NOTICE OF PUBLIC MEETING
Posted September 1, 2022

A public meeting of the Denham Springs Planning and Zoning Commission will be held as follows:

RE: Denham Springs High School – Football and Track Improvements
1000 N. Range Road
Denham Springs, LA 70726

We have received your review letter dated February 14, 2022, for the above referenced project. Please see our formal response to your question regarding event parking at Denham Springs High School.

SHEET L1.00

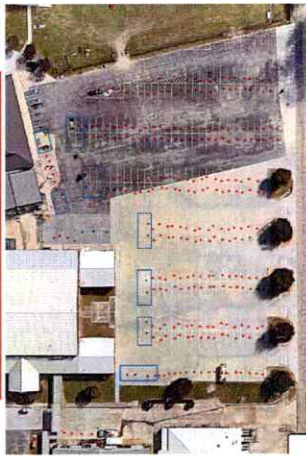
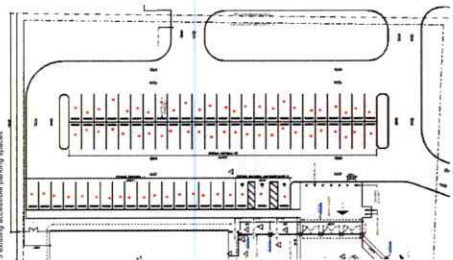
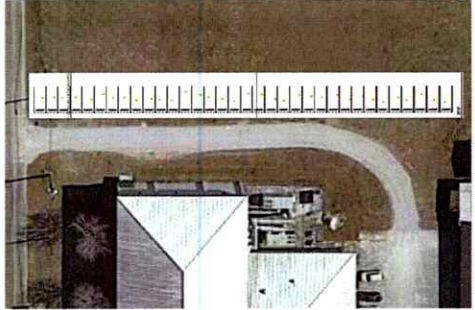
1. Provide calculations detailing the number of parking spaces required for the proposed improvements (football stadium, track, etc.). Though this project is to improve upon an existing facility, additional improvements are also being constructed. Due to the expansion of the existing facilities, ADA parking spaces, including "van accessible" parking space(s), must be provided in accordance with current ADA requirements.

The new football stadium will have a bleacher seating capacity of 5,521 persons. Per Section 2.16, Table 1A of the Denham Springs Zoning Ordinance, stadiums must have one parking space for every 4 seats. Therefore, the ownership team should provide 1,381 vehicles.

Once complete, those attending events at the Denham Springs High School Stadium will have access to approximately 1,383 spaces. A summary of those spaces, their locations and counts are as follows:

24 accessible parking spaces are required for 1,381 parking spaces

33 accessible parking spaces provided

4 van accessible parking spaces are required

4 van accessible parking spaces are provided
